AEP:NRG:1184H  
10 CFR 2.201

Donald C. Cook Nuclear Plant Units 1 and 2  
Docket Nos. 50-315 and 50-316  
License Nos. DPR-58 and DPR-74  
NRC INSPECTION REPORTS NO. 50-315/93012 (DRS)  
AND 50-316/93012 (DRS)  
REPLY TO NOTICE OF VIOLATION

REPLY TO NOTICE OF VIOLATION

Copy of Fieldwalk from NESD

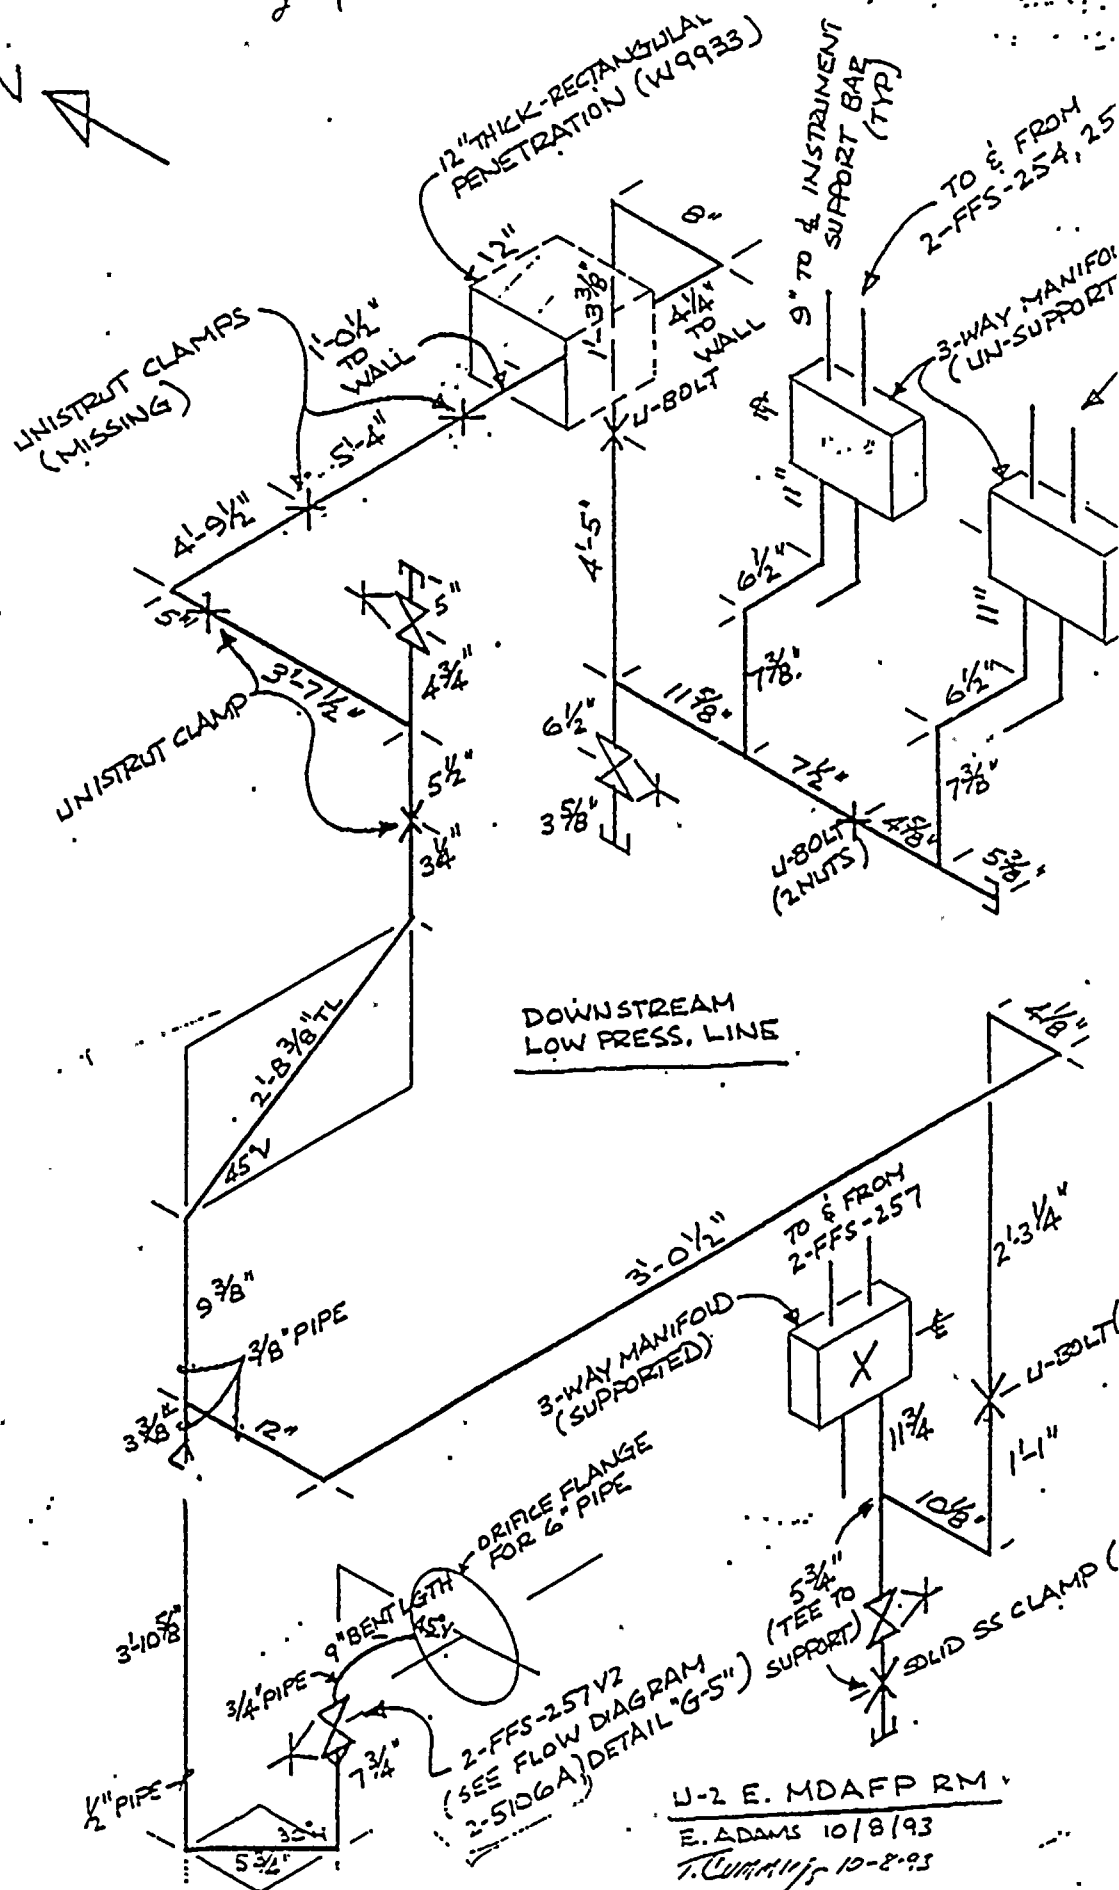
As per your request, the Nuclear Design - Structural & Analytical Section (NEDS) has reviewed the as-found condition detected by an NRC inspector during a NRC SBICI Inspection. The 3/8"φ, 1/2"φ, and 3/4"φ downstream low pressure instrument lines associated with 2-FFS-257, and branch lines off the feed water header line 2-FW-48 were believed to have piping/tubing spans that exceeded Alternate Analysis Criteria.

Based on the above findings, Nuclear Engineering Site Design Section (NESD) performed a detailed walkdown of the piping system (see Attachment A). In order to satisfy the seismic overlap criteria, NESD included additional piping and supports beyond the area addressed by the NRC inspector. In so doing, they found that two support components in the overlap region of the continuation line were missing.

Although the piping system in the as-found condition meets the design basis criteria limits, the two missing components are being installed on the piping system to reflect similarity of pipe supports on identical piping systems in the vicinity, and further to conform with good engineering practice.

It is NEDS understanding that Job Order No. C19393 has been initiated by Plant Maintenance to install the two missing components. If you have any further questions please contact these writers at extension 3157.
